Town of Orangetown Planning Board
Planning Board Meeting: Tuesday, April 7, 2020

Project Name: Instrumentation Laboratory Site Plan

Project Description: Final Site Plan Review

Subject: **Permit # 48870**
Building and Parking Addition – Final Site Plan Documents
Instrumentation Laboratory, Inc.
526 Route 303
Town of Orangetown, Rockland County, NY

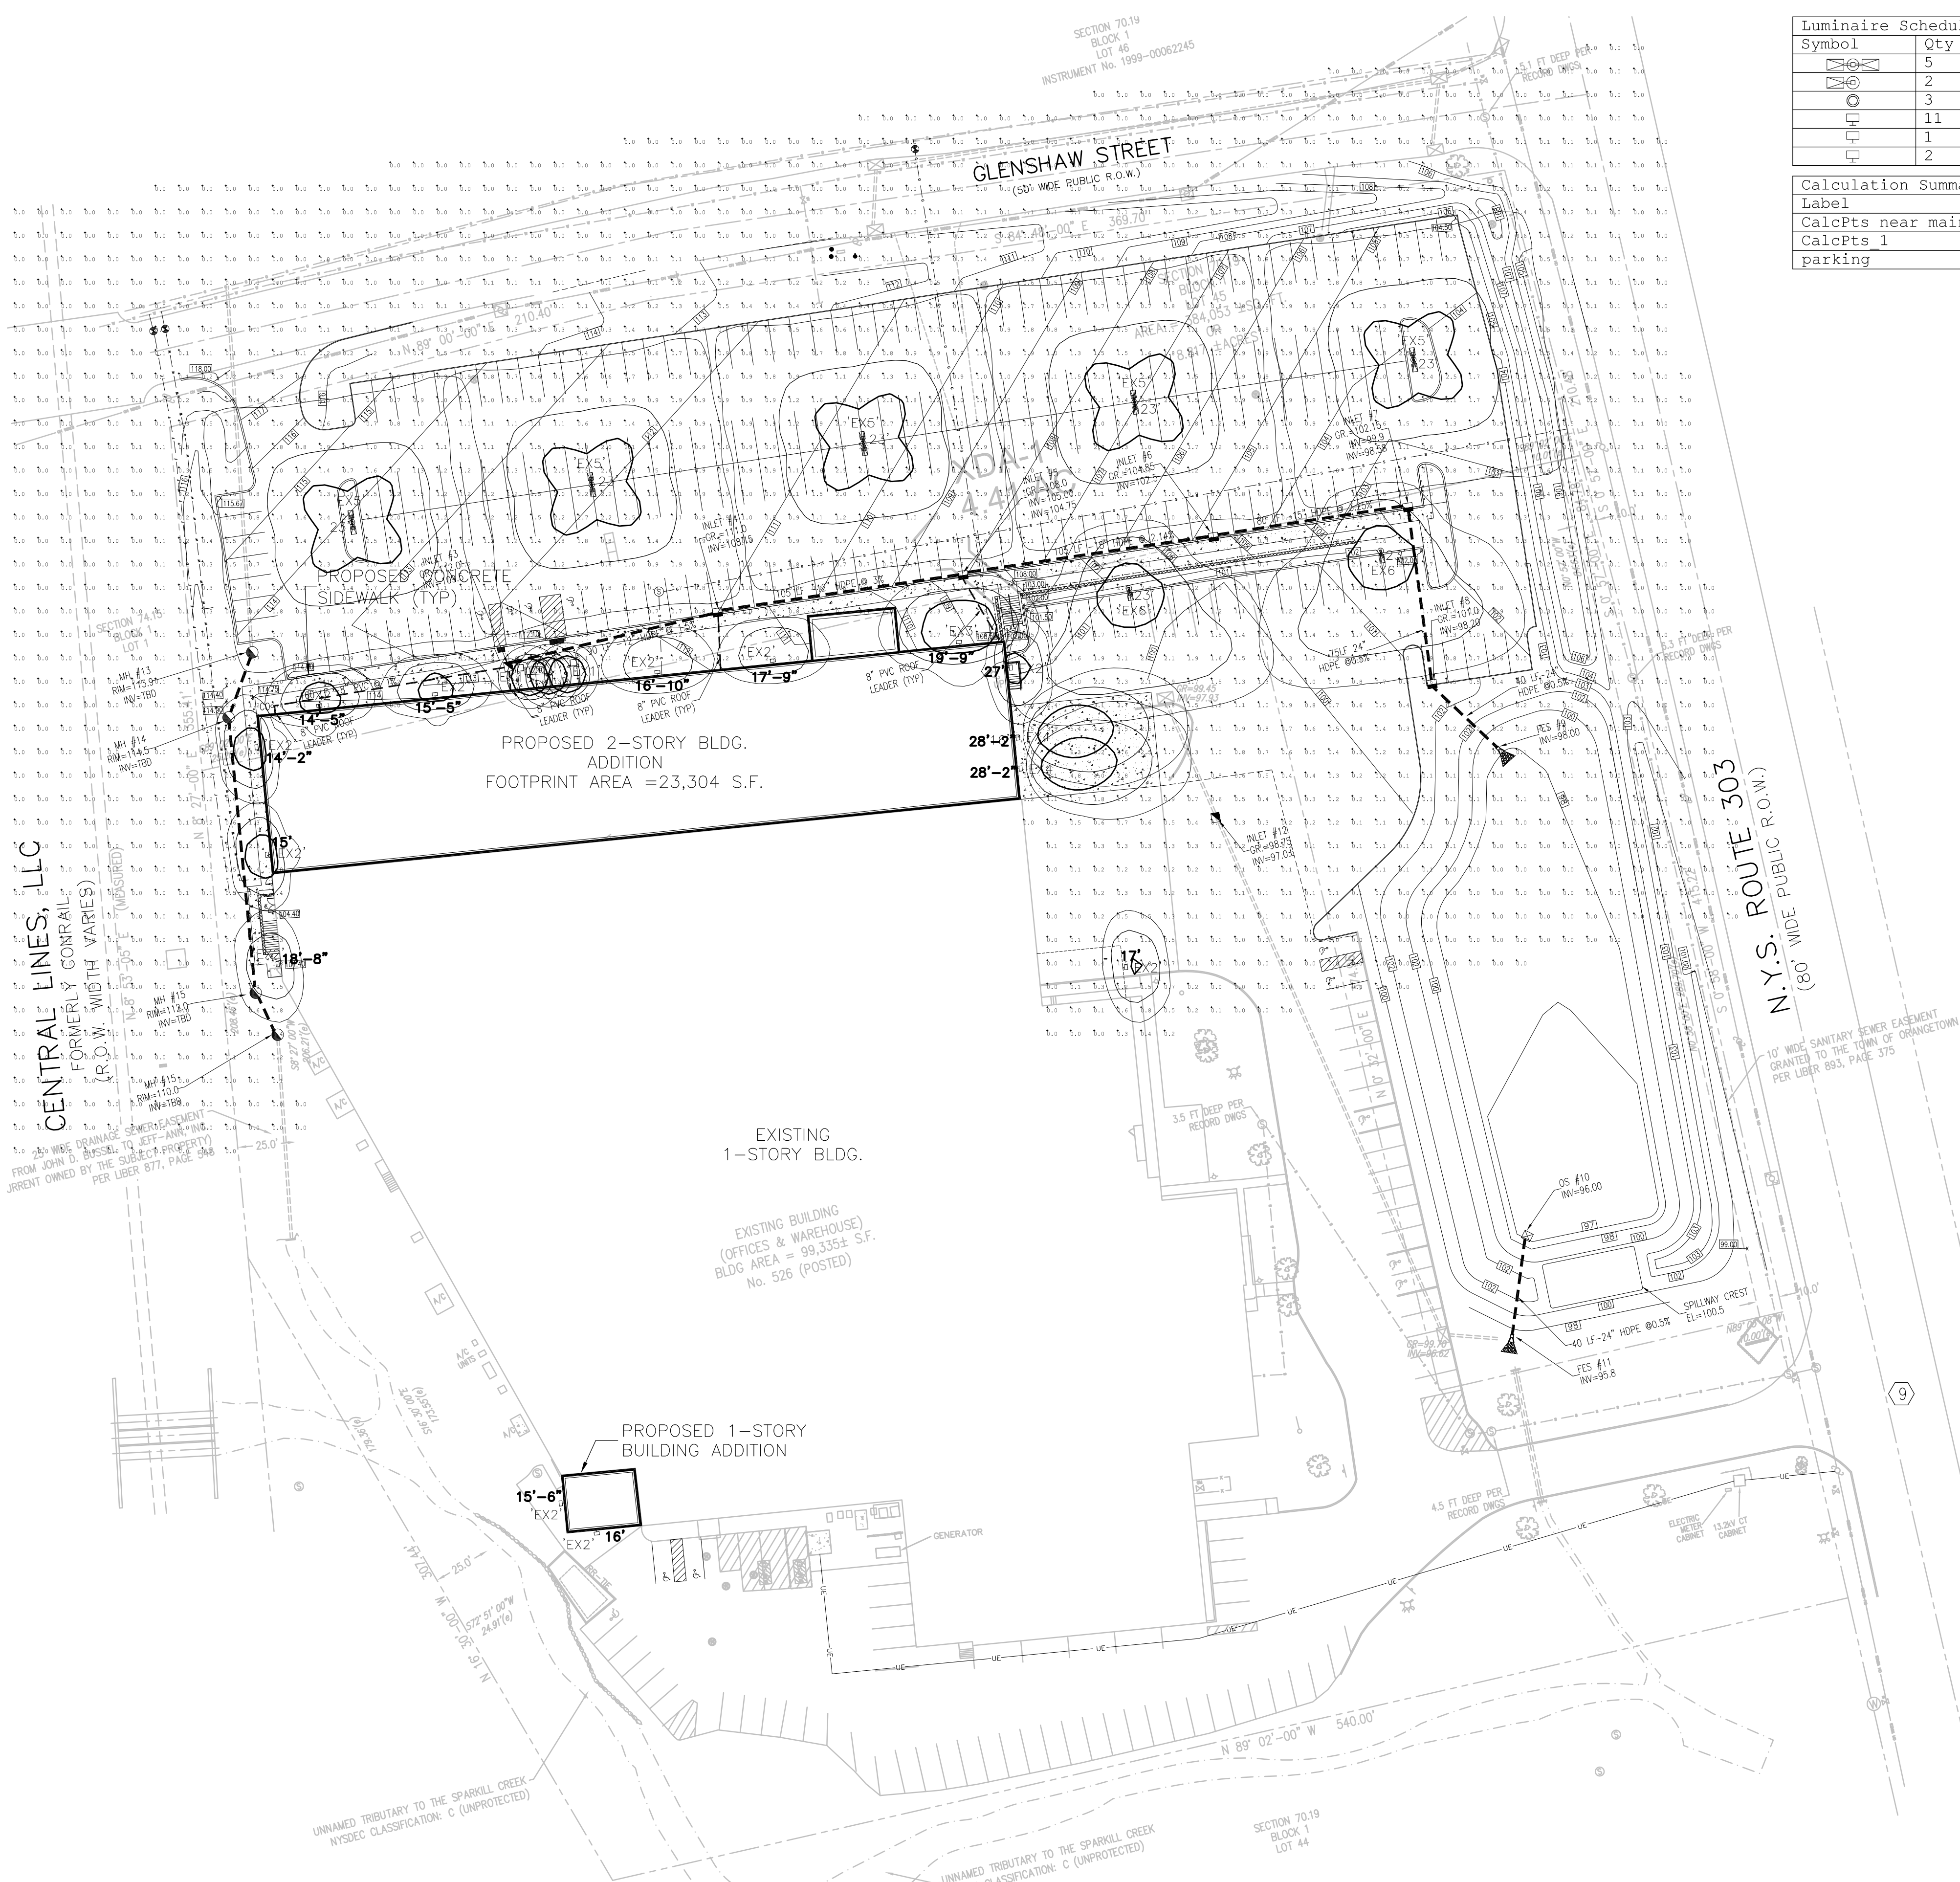
10. No parking is permitted in the 25' drainage easement.
11. Note if there is any building mounted lighting proposed and indicate on the site lighting plan and elevations.

11. Building mounted site lighting has been added to Drawing No. C06.
12. Floor Plans have been previously submitted. Zoning Board Performance Standards Review has been approved.

4. There is no net increase in peak runoff rate.
 5. Drawing No. C06 provided a point by point site lighting analysis.
 6. Plans were approved by Zoning Board for the Route 303 Overlay Zone District.

LANDSCAPED BERM SECTION 4
 SCALE: 1/4" = 1'-0"

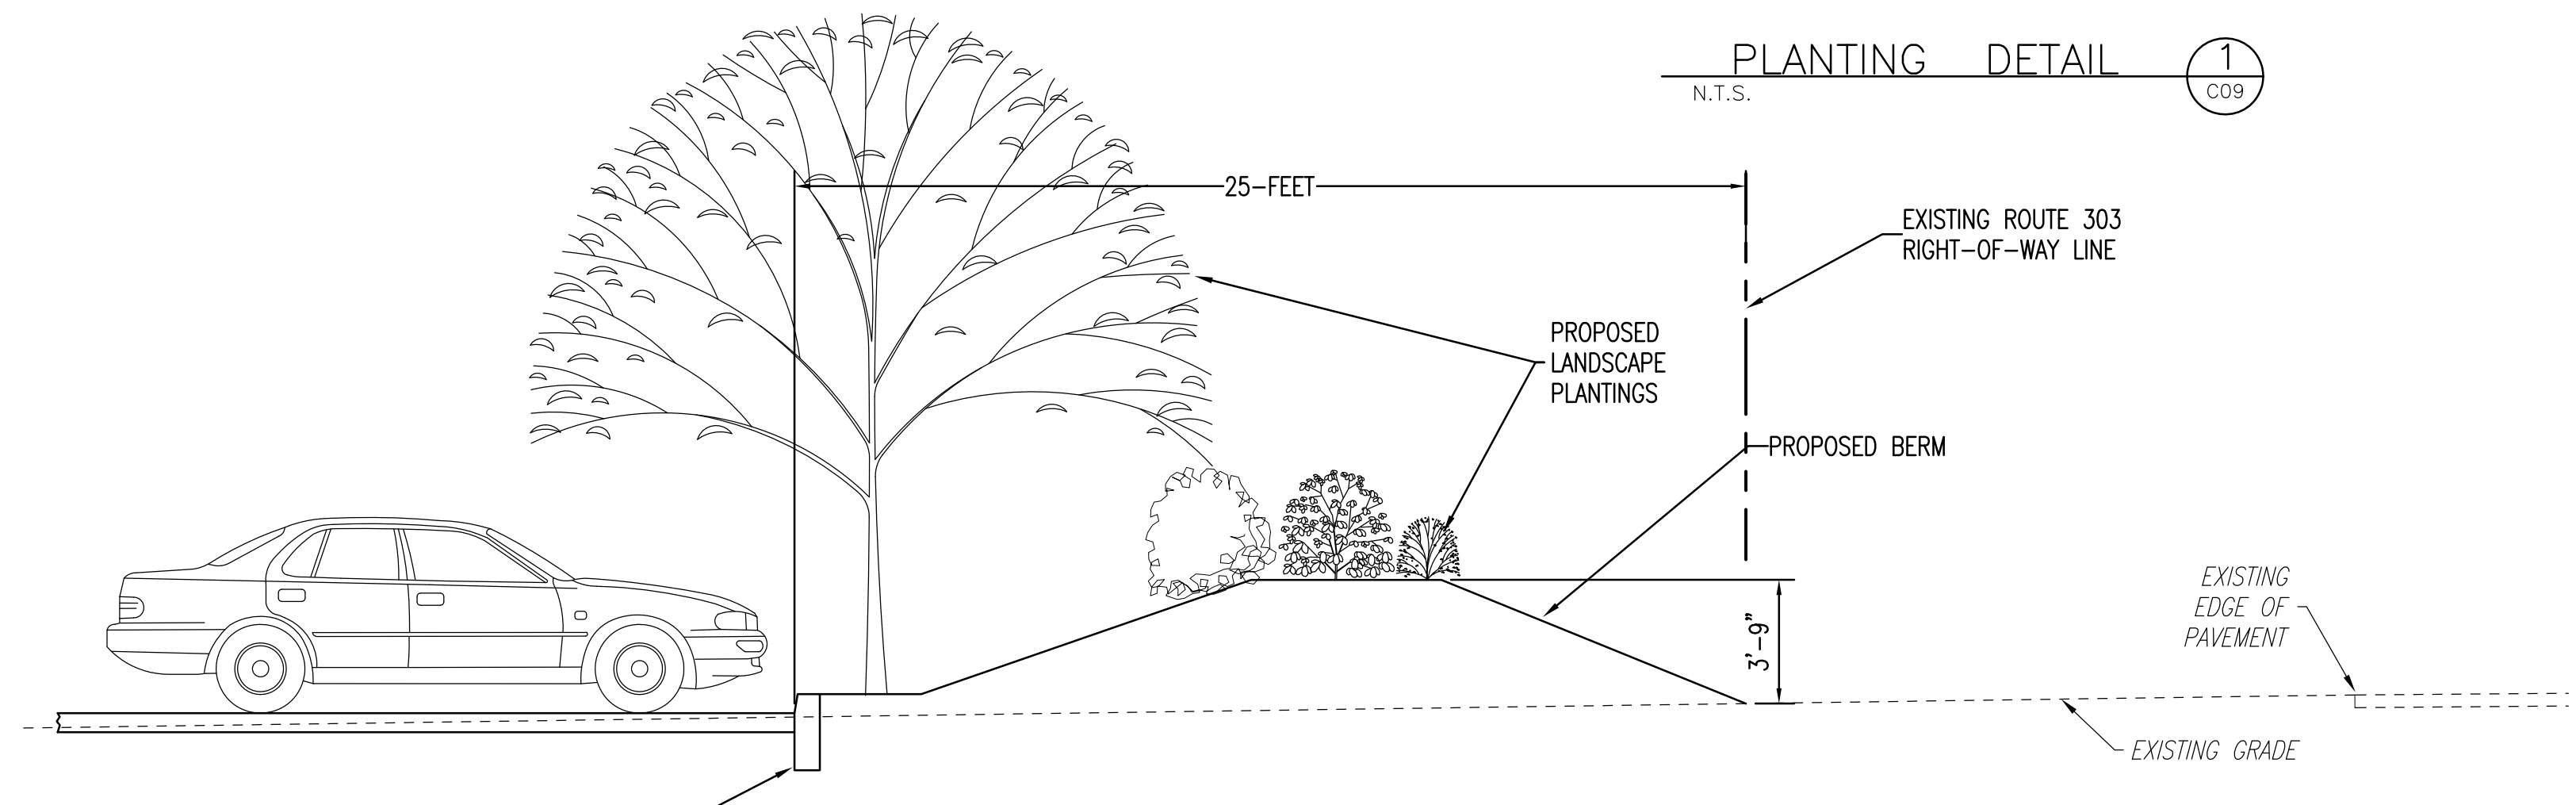
1. General Note #1 has been added to Drawing No. CT01.
2. General Note #2 has been added to Drawing No. CT01.
3. General Note #3 has been added to Drawing No. CT01.
4. The Landscaped Berm Section, Detail #4, on Drawing No. 7 has been revised to indicate a berm height of 3'-9". The berm has been extended southward toward the main entrance from Route 303 and an additional berm is shown on the south side of the main entrance. These berm modifications are reflected by the proposed contours shown on drawing No. C04 and C07.
